**CENTER AISLE HANDRAILS IN SECTIONS 1-9
WILLIAMS BRICE STADIUM
UNIVERSITY OF SOUTH CAROLINA
CP00349450**

**Addendum One
June 4, 2012**

CENTER AISLE HANDRAIL ADDITIONS SECTIONS 1-9
WILLIAMS-BRICE STADIUM
UNIVERSITY OF SOUTH CAROLINA

FLOOR PLAN
1/16" = 1'-0"

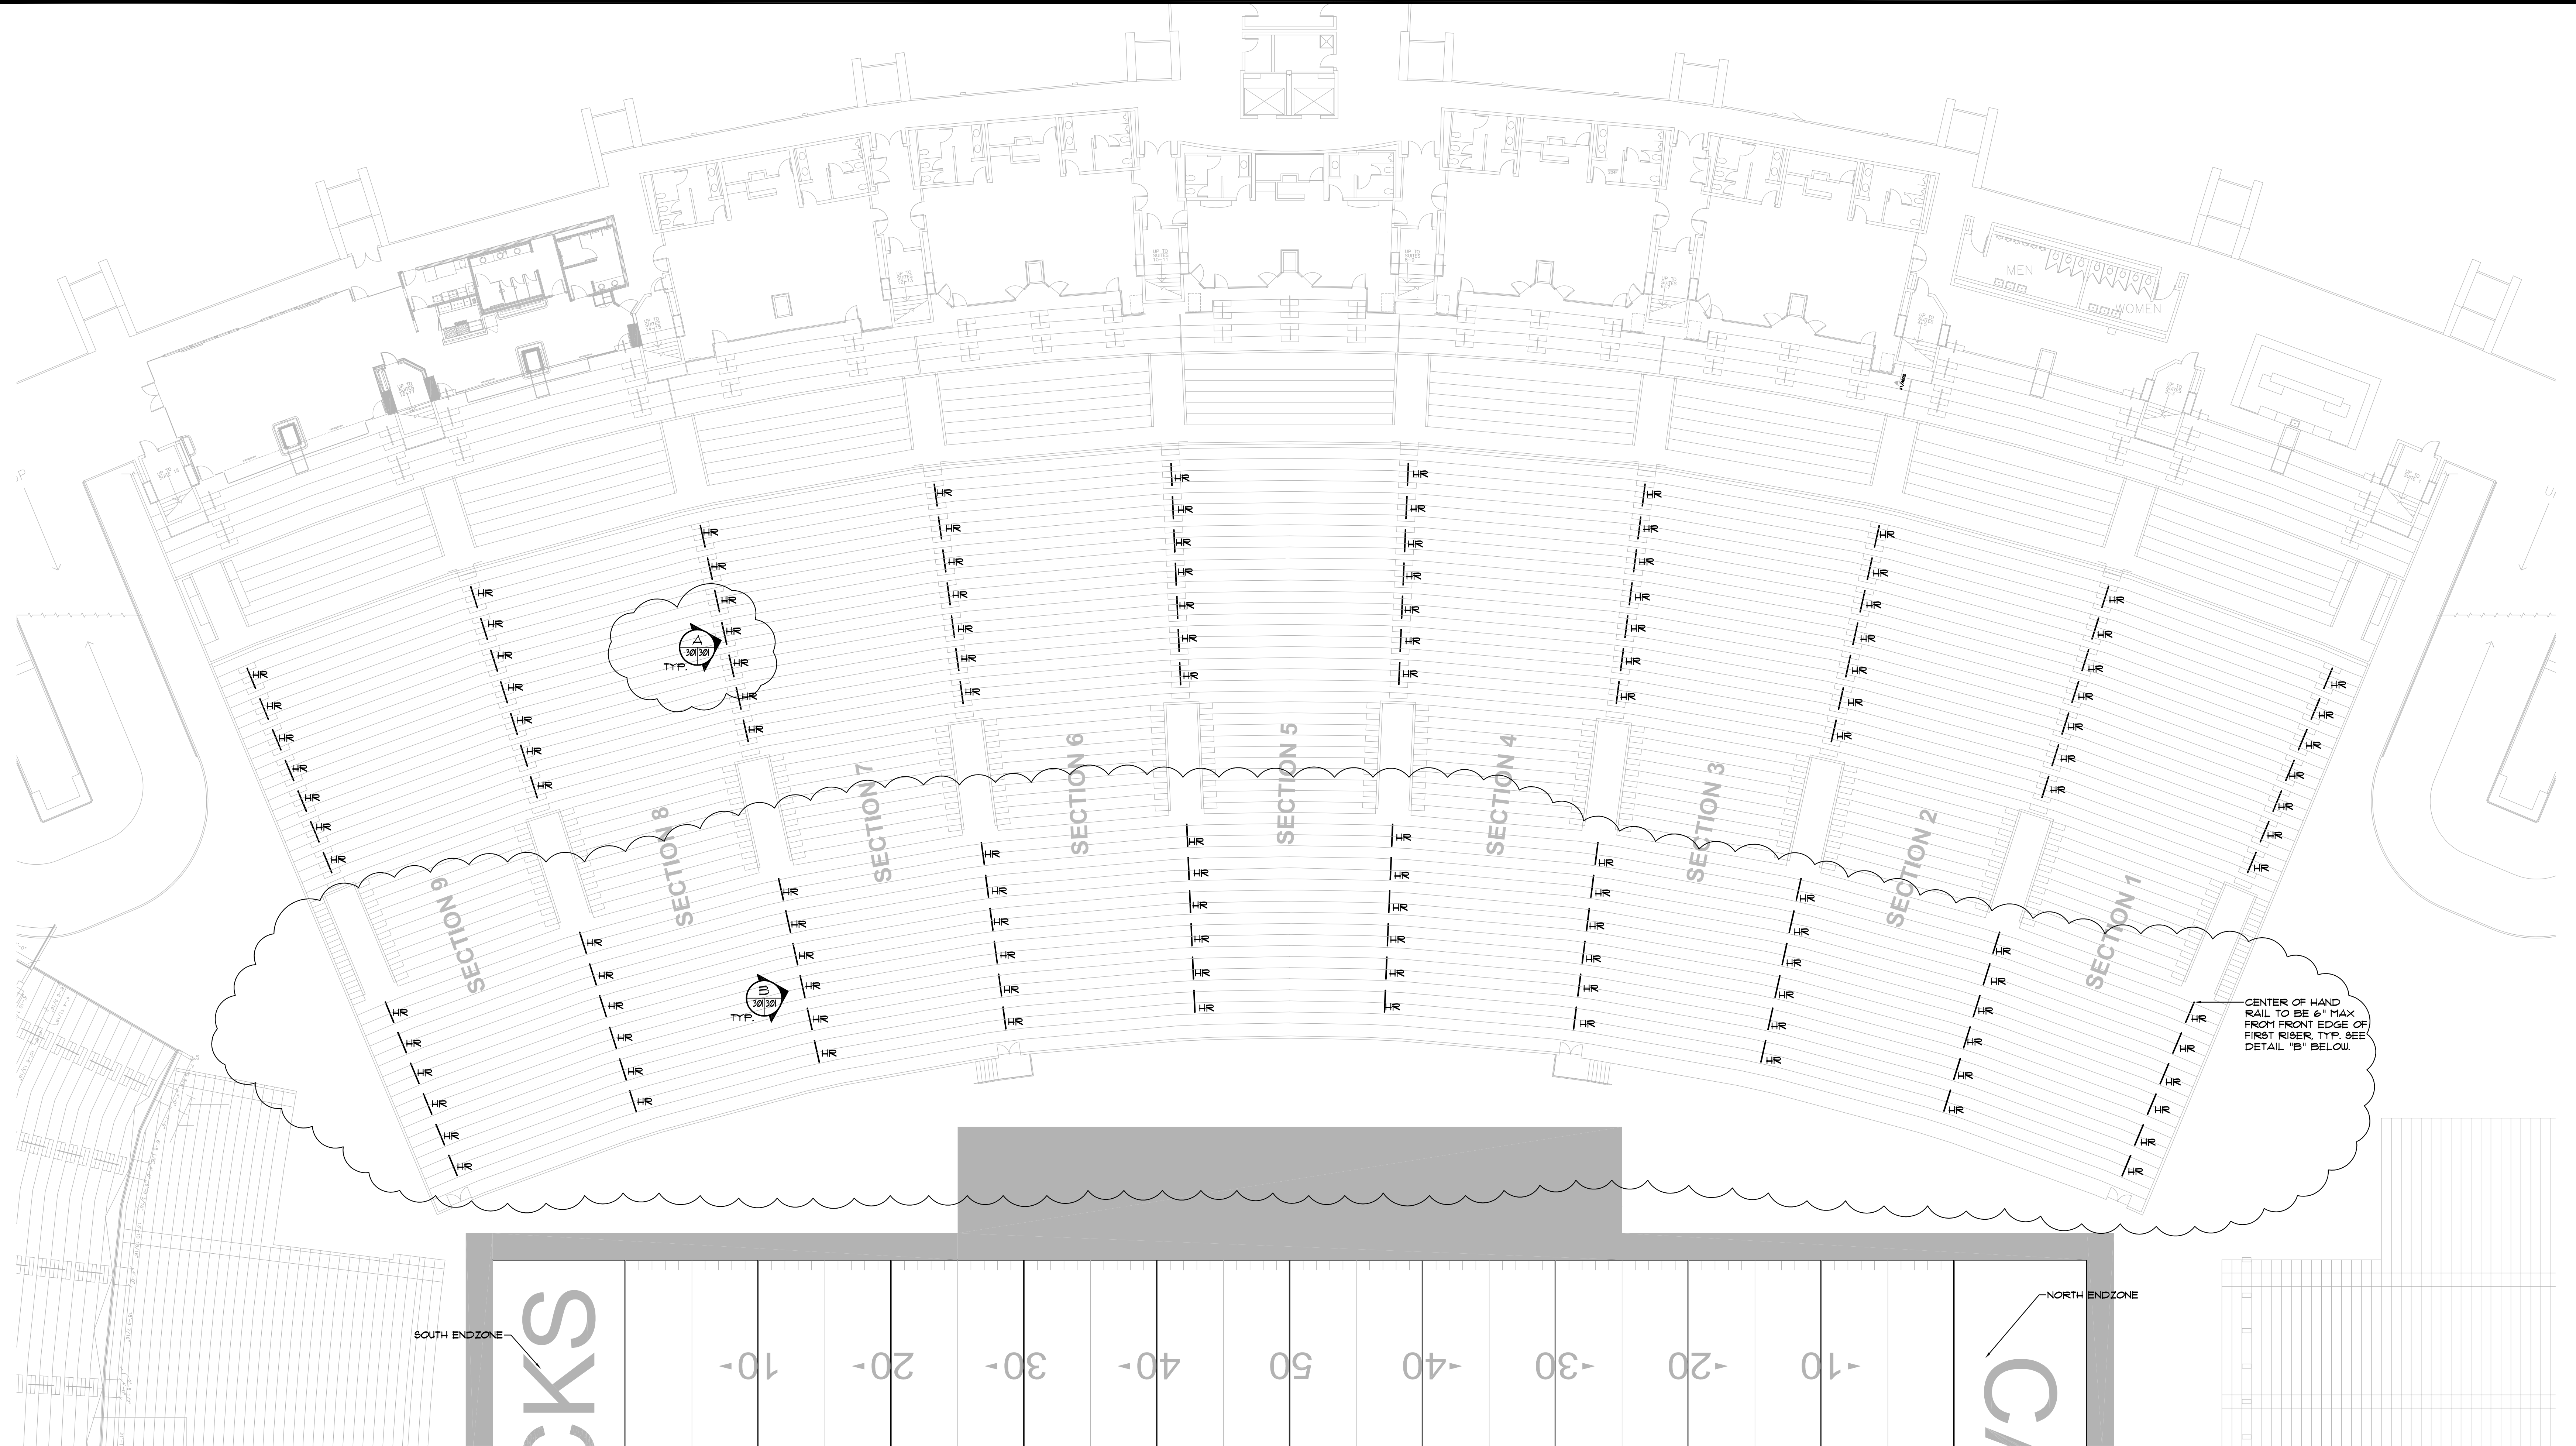
1. Sheet A301:
 - a. Floor Plan – The bottom half of each seating section does not have any intermediate steps as shown on the original plans dated May 7, 2012. See attached revised sheet A301, dated 6/1/2012, for additional details and other information.
